## **CNP UNITS 1 AND 2 IMPROVED TECHNICAL SPECIFICATIONS CONVERSION**

### **ITS SECTION 3.6 CONTAINMENT SYSTEMS**

**Revision 0**

**ITS 3.6.1, Containment**

**INSERT 4**

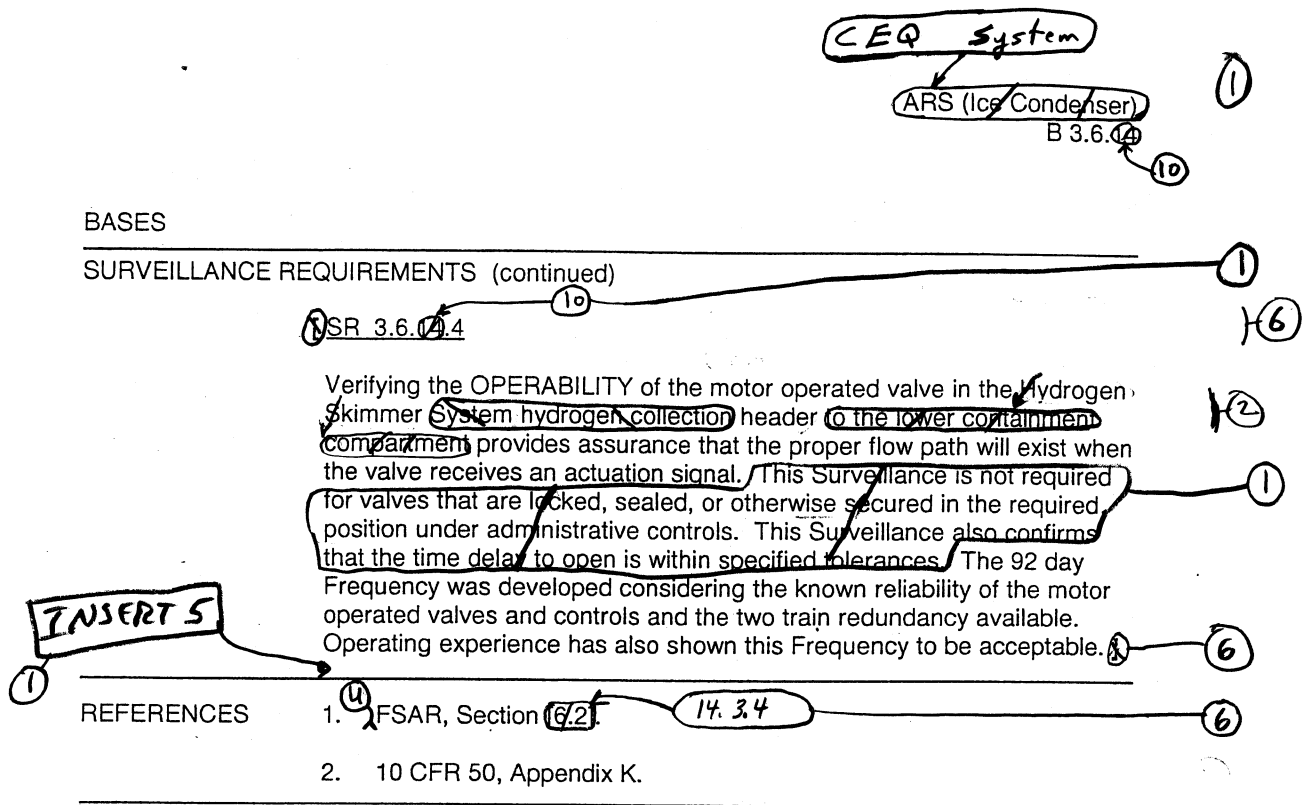
Verifying, with the return air fan discharge backdraft damper locked closed and the fan motor energized, the static pressure between the fan discharge and the backdraft damper is  $\geq 4.0$  inches water gauge confirms one operating condition of the fan. This test is indicative of overall fan motor performance. Such tests confirm component OPERABILITY and detect incipient failures by indicating abnormal performance.
